RESPONSE TO PLANNING COMMENTS INCLUDING CALCULATIONS – Rev. D

SIMPLY UK

HOOK ROAD, PAGHAM

CS&P REF: 9418

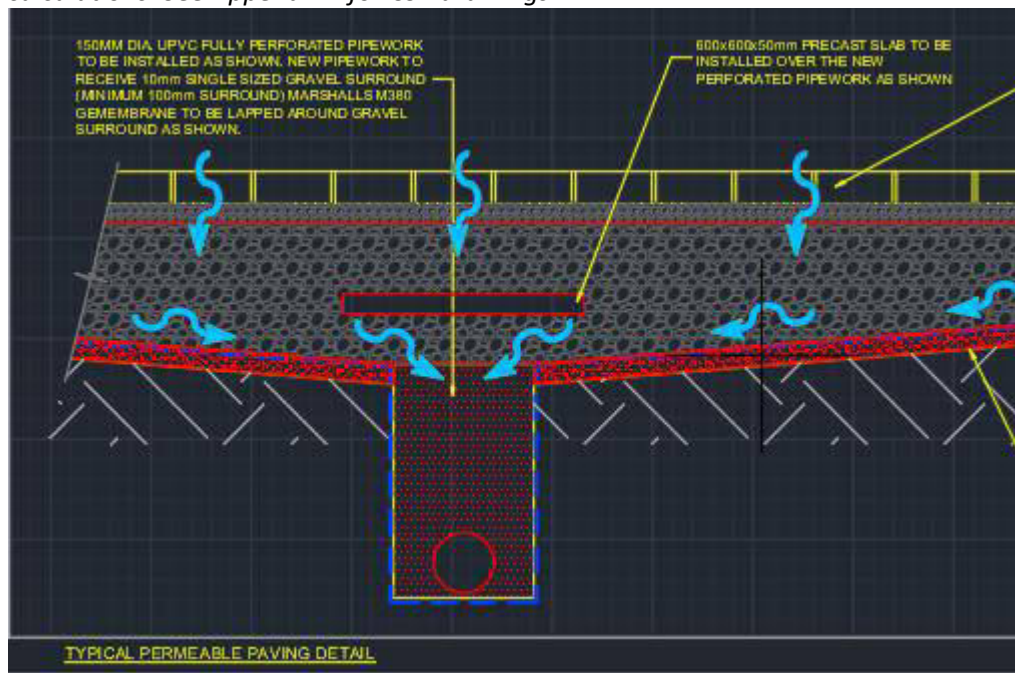
- d) The permeable paving invert level used in the calculations will cause the software to use a depth of 742mm. The depth on the construction details is 200-300mm.

If you review C003 drawing – it is greater than 742mm invert. This has little impact on the calculations. See Appendix F for CSP drawings.
